NIAGARA MOHAWK POWER CORPORATION/NINE MILE POINT, P.O. BOX 63, LYCOMING, NY 13093/TELEPHONE (315) 349-2882

August 23, 1994
NMP2L 1488

RE: Nine Mile Point Unit 2
Docket No. 50-410
NPF-69

Subject: Proposed License Amendment - Up rated Operation, Response to Request for Additional Information

IPE Human Factors Modeling Timeline

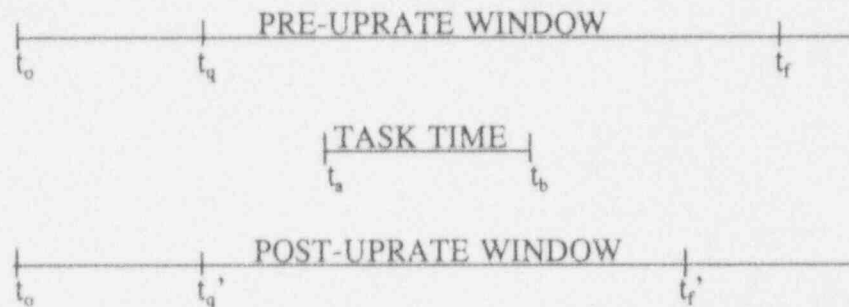
Question 3 - Please discuss whether the power uprate will change the type, scope, or time requirements of operator actions needed for accident mitigation, including the type and scope of plant procedure changes, and any anticipated changes in the scope or nature of operator response.

Timing of events has a direct influence on the probability of successful operator actions. The impact of timing is developed by considering time windows, as above. The time for specific actions to be taken within the time window, i.e. the task time, is developed using walk throughs of procedures to direct the specific task. Generally, the greater the ratio of the time window to the task time, the greater the success probability. This occurs since the operators have a longer time to appraise, respond and correct, as necessary. In this regard, the potential for power uprate to affect accident timing has been considered relative to operator reliability.

The timeline below depicts the IPE treatment of time windows:

In the above, t_0 represents the start of the event, t_q represents the time of the cue to the operator to take a specific action, and t_r is the latest time at which the action can be successful. Similarly, the time from t_a to t_b , the task time, represent the time necessary for the operator to take the specific action. The timeline for t_a to t_b must be accomplished sometime within the period t_q to t_r , the time window. The power uprate has the potential to affect the actual times for specific accident mitigation task time windows. However, severe accident time windows are on the order of several minutes to many hours in duration and uprate related changes to event timings will be on the order of seconds to tens of seconds. In this regard, time window changes on the order of a few seconds, more or less, will have an inconsequential effect on the probability of operator success. As such, t_q' may actually occur a short time before t_q and likewise for t_r . However, in both cases the task time, i.e. the time from t_a to t_b is the same and comfortably fits either time window. For example, the task time for aligning suppression pool cooling is approximately 10 minutes and is primarily a function of the time it takes to start and stop pumps and change valve positions. In both pre and post power uprate configurations much more than 10 minutes, (i.e., approximately 15 hours in the NMP2 IPE), is available for the action to be successful.
